CIMARRON CORPORATION

**Re: Docket No. 70-925; License No. SNM-928
Cimarron Corporation
Revised Drawing #99BG1-XSECC-BB' for Progress Report-Burial Area #1
Groundwater Evaluation dated January 20, 2000**

CIMARRON FACILITY
BURIAL AREA #1
CROSS SECTION B - B'

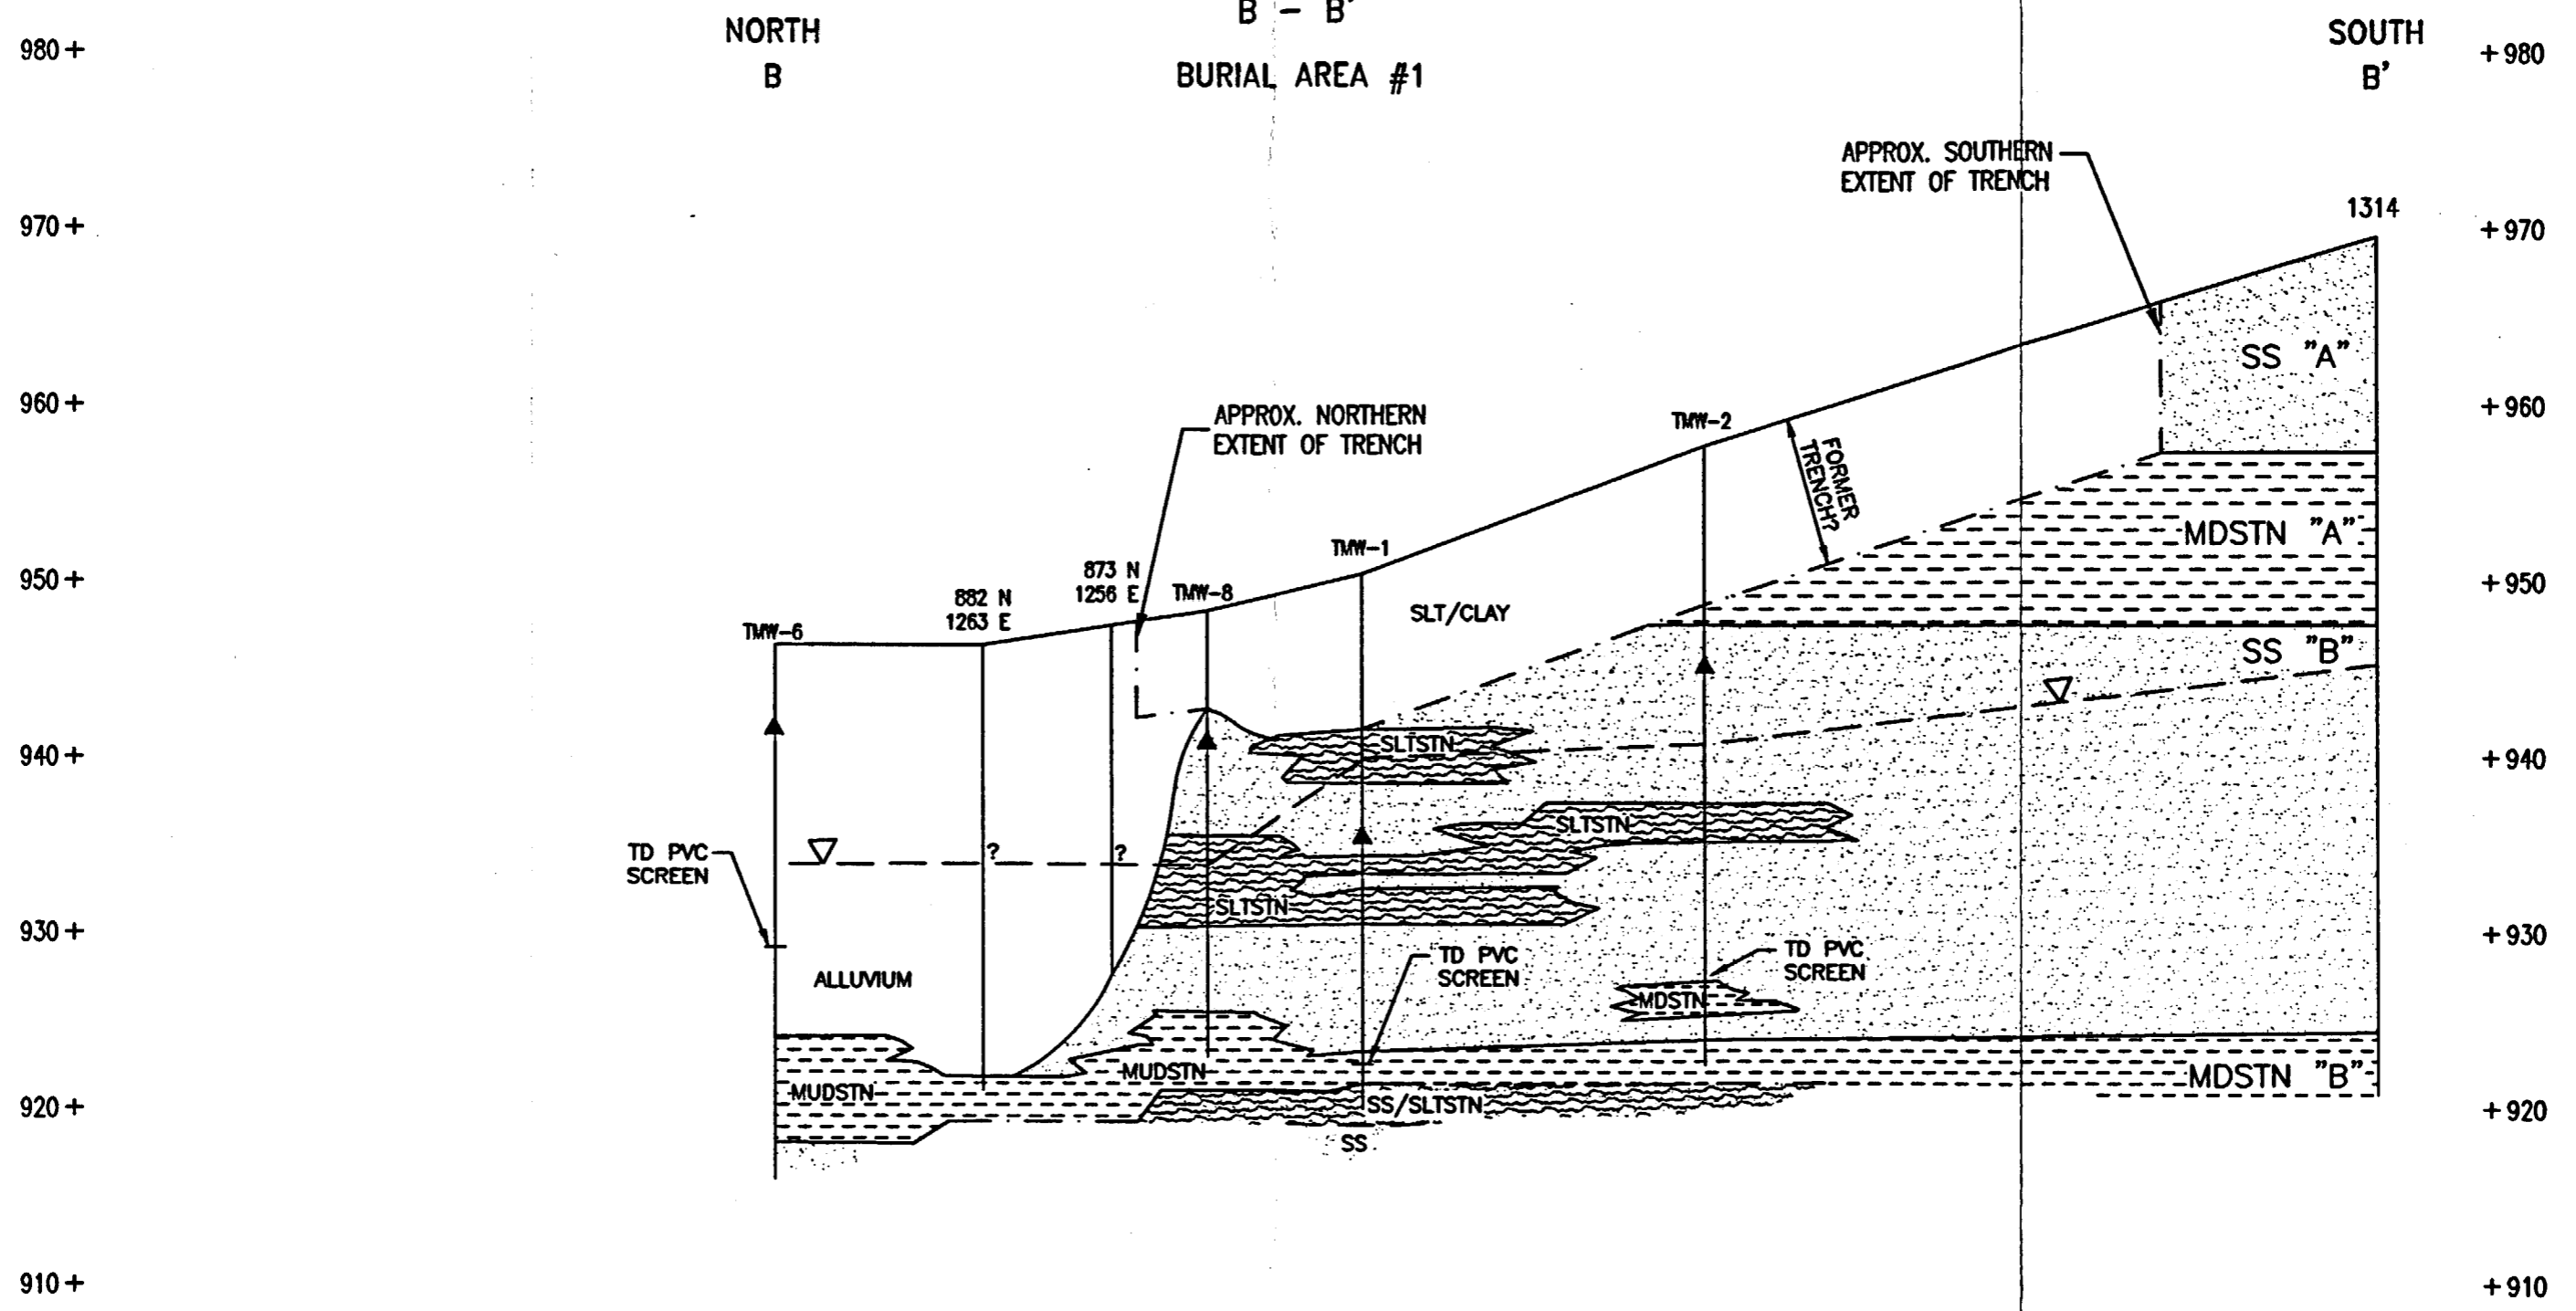
During our conference call on February 3, 2000, you noted that the common portions of cross-sections AA' and BB' as contained in the subject report showed differing information. You were correct in your observation. The cross-section map #99BG1-XSEC-BB' was in error.

A revised cross-section drawing with the same name and revision (Rev.) 1 is provided with which to correct the January 20, 2000, progress report. Copies of the corrected drawing are being provided to all recipients of the original report, and I ask you and all other recipients to remove the original drawing and replace it with the one enclosed herewith.

REV.	DESCRIPTION	DRWN BY:	CHKD BY:	APP'D BY:	DATE	DRWN BY:	DATE	SCALE
1	SECTION AREA MODIFIED FROM TMW-1 TO WELL 1314.	JE	JC	JL	2/18/00	JE	10/23/99	AS SHOWN
0	DRAWING ISSUED.	JE	JC	JL	1/19/00
